PLANNING, ZONING, & BUILDING DEPARTMENT
PZ&B Staff Combination Memorandum: Architectural Commission and Town Council

SUBJECT: ARC-23-145 (ZON-23-113) 123 CHILEAN AVE (COMBO)

MEETING: JANUARY 24, 2024 ARCOM
FEBRUARY 14, 2024 TC

Neighborhood Capture of Plat of Royal Park Addition

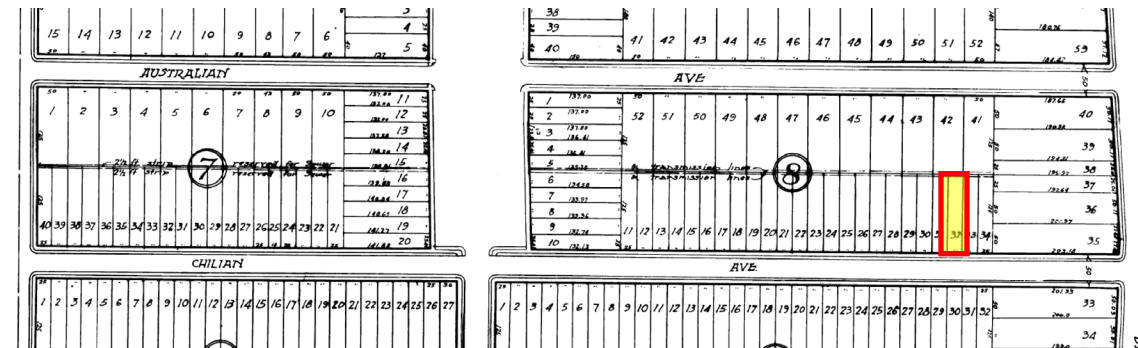
A **Special Exception** is also requested from the Town Council to permit the development of this lot due to its substandard size, yet it is contextually appropriate for the mix of development pattern on this street. A 100' lot width is required, with only 50' existing. And a lot area of 10,000 sq ft is required, with only 6,520 sq ft available. A lot depth of 100' is required, and this property does exceed this requirement with a 125' lot depth. Additionally, the site was previously improved with a single-family residence. A special exception is required to develop a parcel comprised of portions of platted lots. The property is assembled with the East 10 ft of Lot 10, all of Lot 32, and the West 15 of Lot 33 of the Plat of Royal Park Addition.
